DRAFT PLAN TO ADDRESS DWR'S CORRECTIVE ACTIONS

- CGA received DWR's GSP determination on 26 October 2023.
- Approval letter included six Recommended Corrective Actions (RCAs).
- WY 2024 Annual Report Table AR-10 will need to summarize progress made towards addressing the RCAs.
- RCAs must be addressed during the GSP Periodic Evaluation (2027).

Cosumnes GSP: Figure PA-2 Well Density from DWR Well Completion Reports

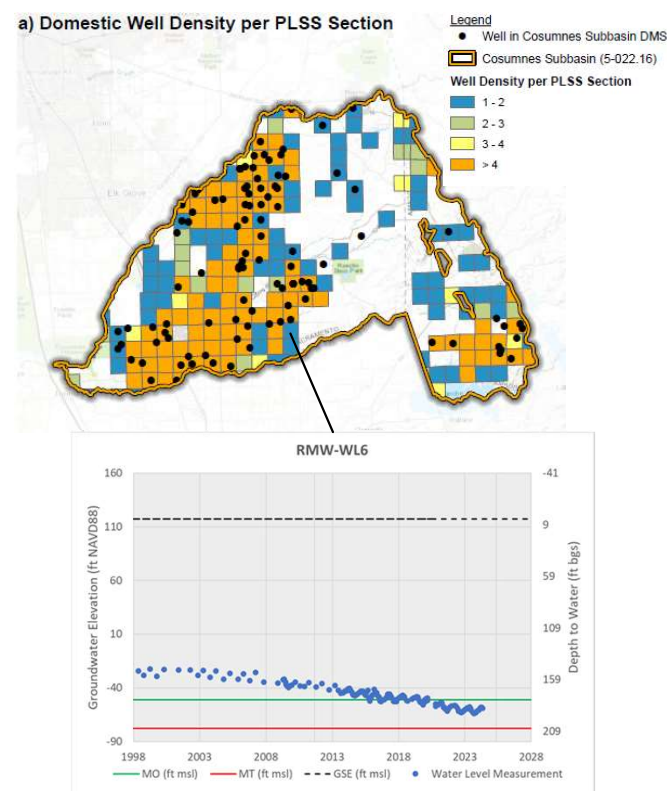
- **Corrective Action 1:** “Further assess potential impacts of the established minimum thresholds for chronic lowering of groundwater levels on **domestic wells** as related data gaps are filled and provide supporting documentation of the assessment.”

- OWSCR database does not have all wells and does not include reliable locations.
- OWSCR database had 2,349 Domestic wells within the Basin.
- GSP concluded 18 Domestic wells could be partially dewatered, and 12 domestic wells could be fully de-watered if groundwater levels fell beneath the MTs at all representative monitoring wells (*conservative because it is an unlikely scenario*).

Cosumnes GSP
Figure SMC-2 Well Impact Analysis

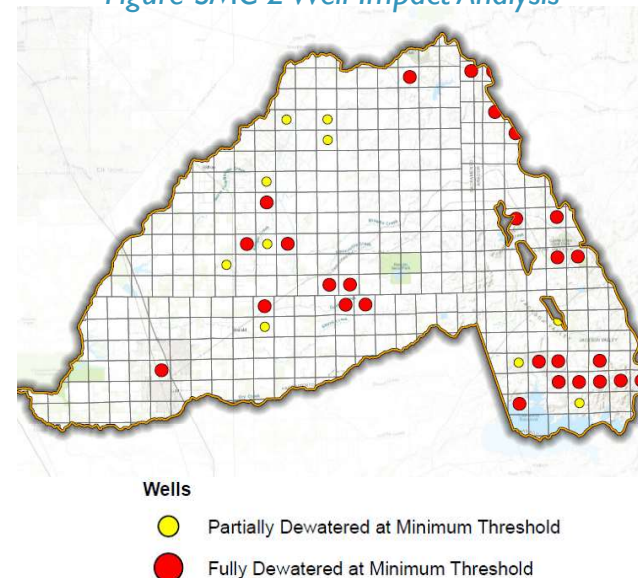
Department staff believes many users will utilize wells more than 40 years old throughout the GSP implementation period and note this equates to nearly 600 domestic wells potentially impacted by GSP implementation that were excluded from the well impact analysis.

- **GSA:** Conduct well census and inventory projects to verify well use, status, construction, and density within the Basin (Data gap identified in Section 19.1.2. Data Gap Filling Efforts)
- **CGA/GSP Consultant:** Update and document domestic well impact analysis after well census is completed.

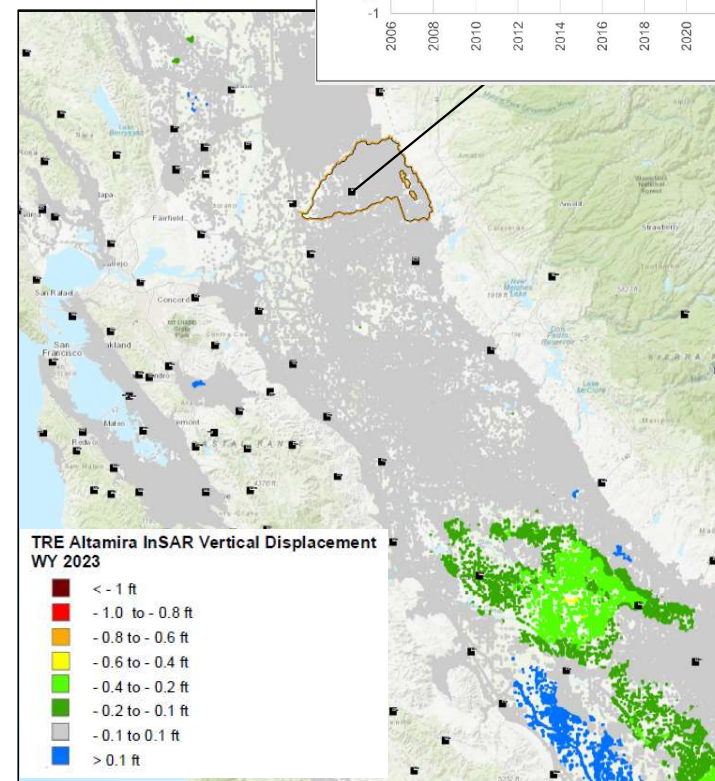
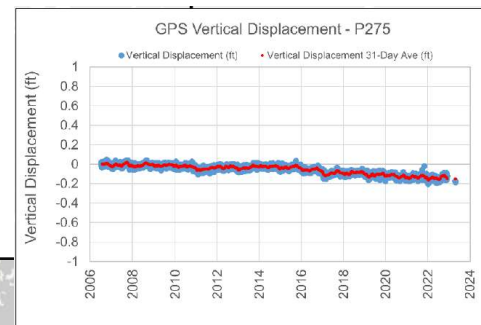
Department staff note that at this time, the Plan does not demonstrate, with adequate evidence, that the use of groundwater elevations as a proxy for depletions of interconnected surface water is sufficient to quantify the location, quantity, and timing of depletions.

- **CGA/GSP Consultant:** Utilize interconnected surface water guidance, as appropriate, when issued by DWR, to establish/refine quantifiable MTs, MOs, and management actions (MAs).
- **GSA fill data gaps:** additional monitoring data, monitor and identify timing and extent of interconnectivity.
- **CGA/GSP Consultant:** Refine CoSANA-calculated surface water depletions consistent with DWR guidelines.
- **CGA:** Prioritize collaborating and coordinating with local, state, and federal regulatory agencies and other interested stakeholders to better understand the beneficial uses and users potentially impacted by pumping induced surface water depletions within the GSA’s jurisdictional area (for example, reactivate the Surface Water Advisory Group [SWAG]).
